ECN/PCN No.: 3729

<b>Product Description:</b> Low Jitter Crystal Oscillator	<b>Abraccon Part Number / Part Series:</b> ABLJO	<input checked="" type="checkbox"/> Documentation only <input checked="" type="checkbox"/> ECN <input type="checkbox"/> EOL	<input checked="" type="checkbox"/> Series <input type="checkbox"/> Part Number
<b>Affected Revision:</b> D	<b>New Revision:</b> E	<b>Application:</b>	<input type="checkbox"/> Safety <input checked="" type="checkbox"/> Non-Safety

Reflow profile:

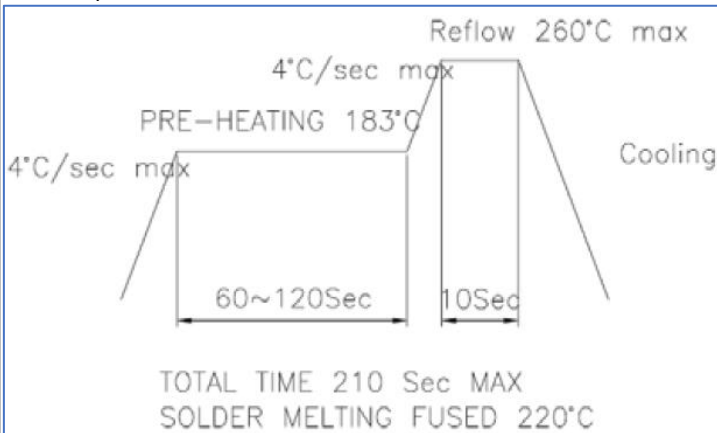
### Prior to Change:

Reflow profile:

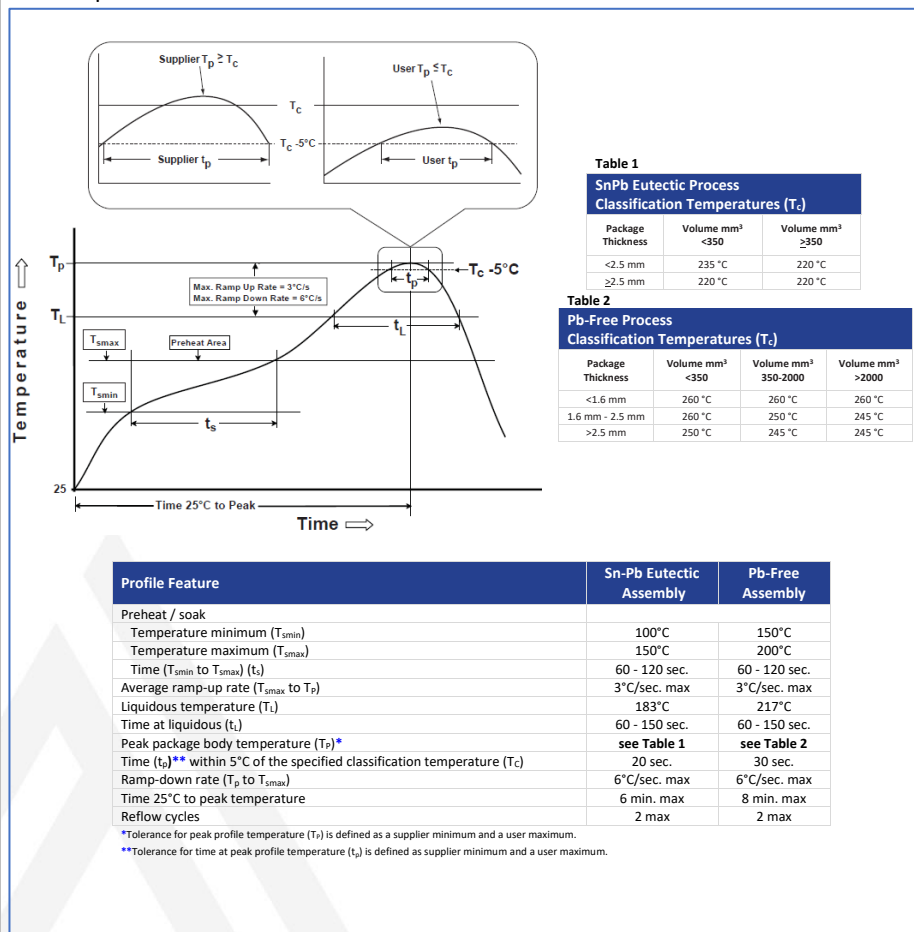
### After Change:

Updated reflow profile to JEDEC J-STD-020.
